SAFETY RECALL

CERTAIN MODEL YEAR 2026 TW200 MOTORCYCLES

FACTORY MODIFICATION CAMPAIGN – Speedometer Drive Gear Malfunction

GEAR UNIT ASSEMBLY

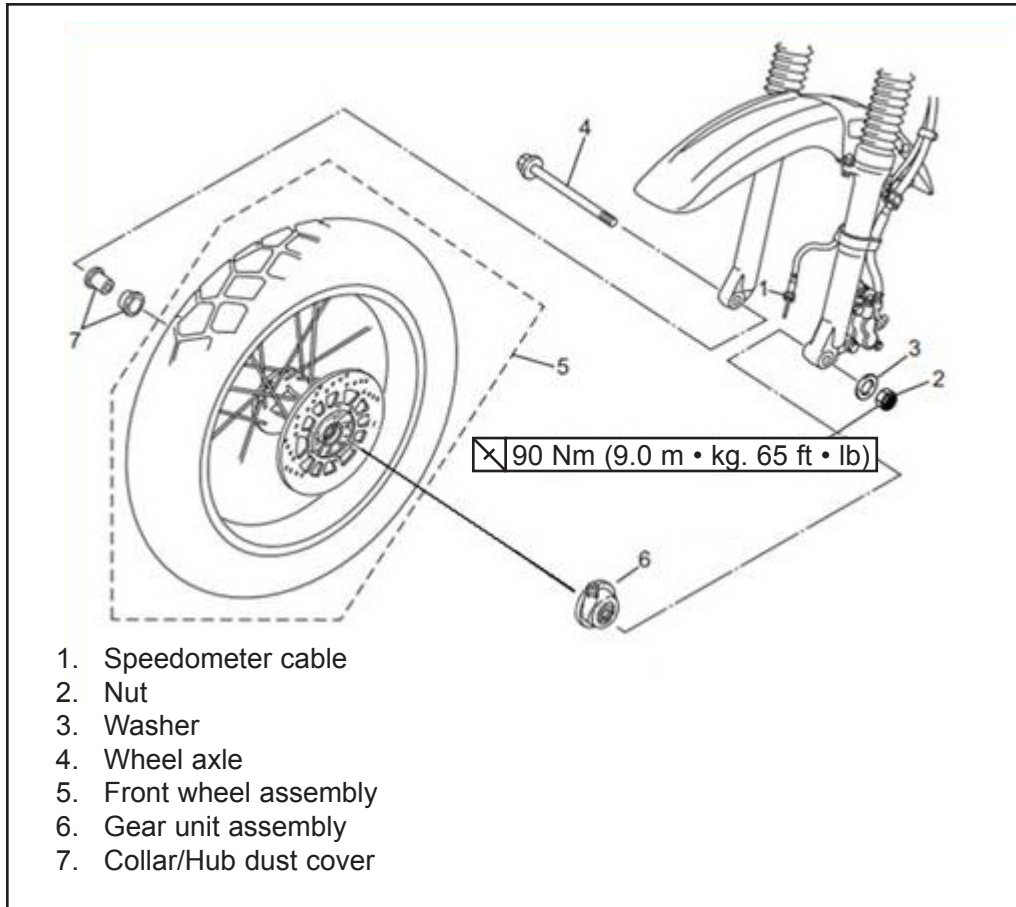
The front wheel's Gear Unit Assembly, which drives the speedometer cable, may not be rigid enough. It can deform and not turn correctly after the axle bolt is tightened. If so, the speedometer may display inaccurate speed or may not work at all. If this happens, the operator may become distracted or unable to assess the vehicle's speed, which could result in the loss of control potentially leading to a crash with severe injury or death.

To correct this defect, Yamaha Motor Corporation, U.S.A. has been directed to initiate a Factory Modification Campaign. Affected units must have the Gear Unit Assembly replaced.

INSTALLING NEW GEAR UNIT ASSEMBLY

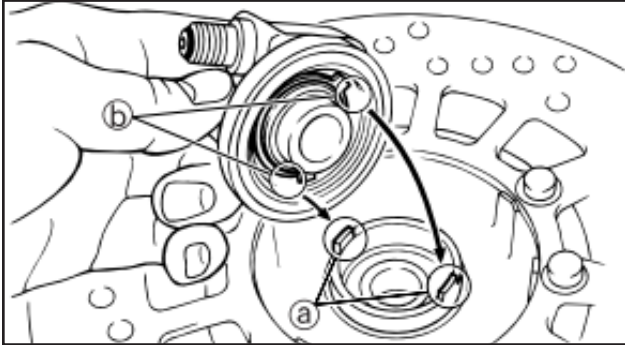
1. Place the vehicle on a maintenance stand so the front wheel is elevated.
2. Remove the speedometer cable (1) from the gear unit assembly (6).
3. Remove the front wheel assembly (5). Set aside the collar/hub dust cover (7), washer (3) and nut (2) as they will be reused.
4. Remove the old gear unit assembly (6).

1. Clean any existing grease, dirt, and debris, from the nut (2), washer (3), and wheel axle (4). Then apply a thin coating of lithium-soap-based grease to the wheel axle. **Take care not to get any grease on the threads of the wheel axle.**
2. Install the new gear unit assembly onto the front wheel. Make sure the projections (a) in the wheel hub are aligned with the slots (b) in the gear unit.

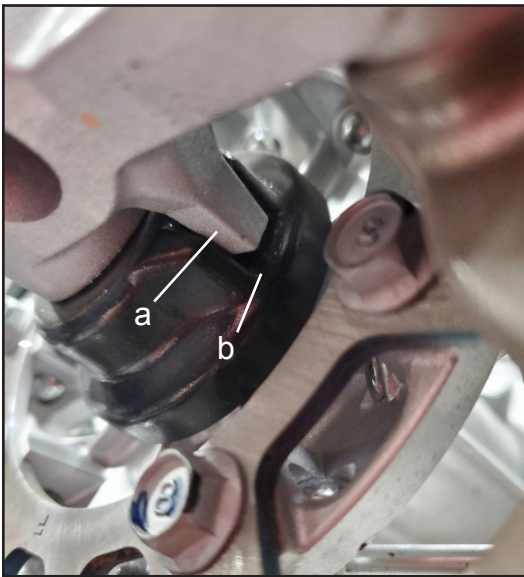
3. Install the front wheel assembly to the front fork in the reverse order of removal. Make sure the projection (a) (torque stopper) on the front fork is placed (b) in the gear unit assembly as shown. Hand-tighten the wheel axle nut.

4. Before torquing the wheel axle nut, check that the fork rebounds smoothly by removing the vehicle from the maintenance stand and pushing down hard on the handlebars several times to observe proper rebound. Then place the vehicle back on the maintenance stand.
5. Tighten the wheel axle nut (2) to 90 Nm (9.0 m·kg, 65 lb·ft).
6. Install the speedometer cable (1) into the gear unit assembly.
7. Rotate the front wheel and check that the speedometer is working properly.
